# CITY OF PORTLAND

# BUILDING PERMIT

Job ID: 2012-06-4358-CH OF USE

**Jeanie Bourke - RE: 56 Hammond St BP#2012-06-4358 & 4359 plan review comments**

**SK-2**

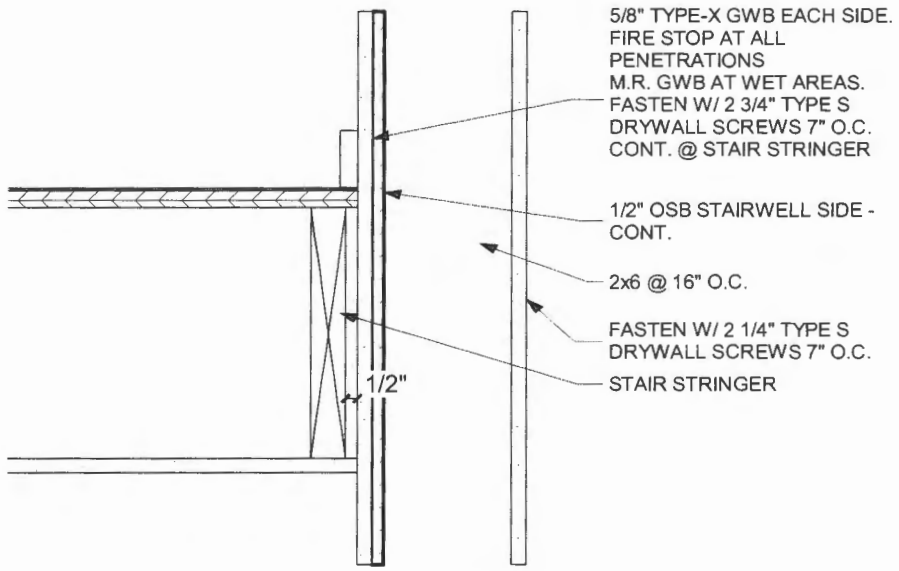
· Provide justification for the .5 hour ceiling type (2 clg) on Plan A000 per IBC Sec. 712.3  
*Section 709.3 exception 2 allows a rating of 1/2 hour in buildings of type VB construction equipped with an automatic sprinkler system. This assembly rendered moot by your question regarding sound transmission below. See attached SK-2 drawing defining new assembly.*

· Provide W/C assembly compliance for sound transmission per IBC Sec. 1207

REPLACE WALL TYPE 1-B AT STAIRWELL AND HALL WITH ASSEMBLY BELOW. RESILIENT CHANNEL TO BE APPLIED TO APARTMENT UNIT SIDE OF ASSEMBLY. 1/2" OSB TO REMAIN ON STAIR SIDE OF WALL PER STRUCTURAL DRAWINGS.

REPLACE CEILING TYPE 2-CLG WITH ASSEMBLY BELOW.
